Well Name: GOLD MEDAL	Well Location: T24N / R10W / SEC 31 / NESE / 36.268036 / -107.929764	County or Parish/State: SAN JUAN / NM
Well Number: 3	Type of Well: OIL WELL	Allottee or Tribe Name:
Lease Number: NMNM22044	Unit or CA Name:	Unit or CA Number:
US Well Number: 300452682200S1	Operator: DUGAN PRODUCTION CORPORATION

Type of Submission: Notice of Intent	Type of Action: Plug and Abandonment
Date Sundry Submitted: 03/12/2025	Time Sundry Submitted: 04:24
Date proposed operation will begin: 03/20/2025

Notice of Intent – Plug and Abandonment

Operator: Dugan Production Corporation
Lease: NMNM22044
Well(s): Gold Medal 3, US Well # 30-045-26822
Location: NESE Sec 31 T24N R10W (San Juan County, NM)
Sundry Notice ID #: 2841511

Planned P & A Schematic

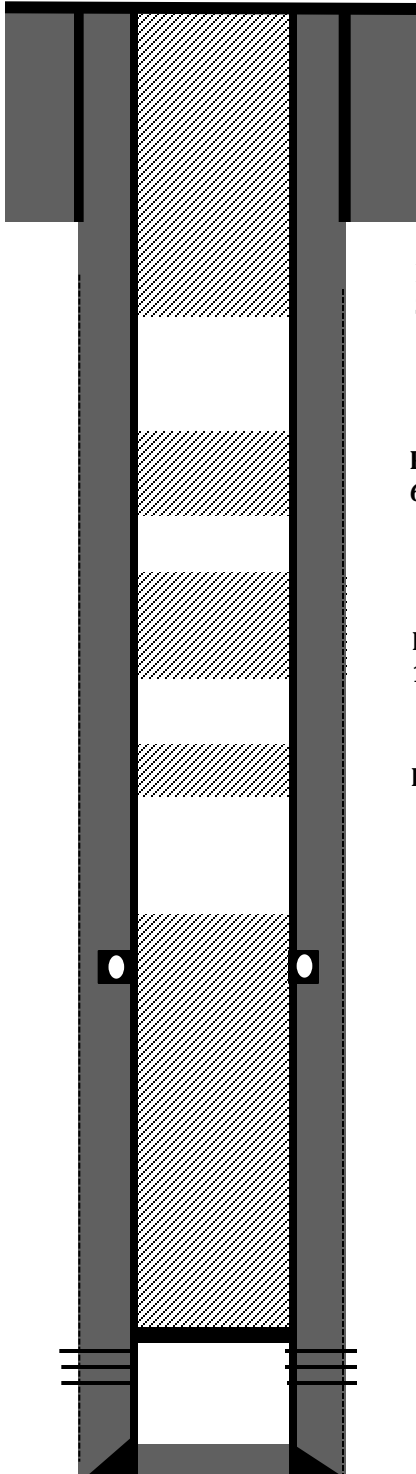
1. Plugging operations authorized are subject to the attached "General Requirements for Permanent Abandonment of Wells on Federal and Indian Lease."
2. The following modifications to your plugging program are to be made:
 - a. Modify Plug 1: Move TOC to 3420' to cover the BLM geologist's pick for the Mancos at 3520'.
 - b. Modify the Plug 2 BOC to 2365' and the TOC to 2215' to account for the BLM geologist's pick for the Cliff House at 2315'.
 - c. Modify Plug 5: Move BOC to 450' to cover the BLM geologist's pick for the Kirtland at 400'.
3. **Notification:** Farmington Office is to be notified at least 24 hours before the plugging operations commence at (505) 564 7750.

- Vertical wellbore, all formation depths are TVD from KB at the wellhead.
- BSC: behind surface casing
- Modify the Plug 2 BOC to 2365' and the TOC to 2215' to account for the BLM geologist's pick for the Cliff House.
- Modify Plug 5: Move BOC to 450' to cover the BLM geologist's pick for the Kirtland.

Created By	Condition	Condition Date
mkuehling	NMOCD agrees with BLM tops except for PC = 1018 and Fruitland Coal = 700 - adjust plugs accordingly - extend plug 1 to 50 feet below Gallup top - Notify NMOCD 24 hours prior to moving on - monitor string pressures daily report on subsequent - submit all logs prior to subsequent	3/19/2025
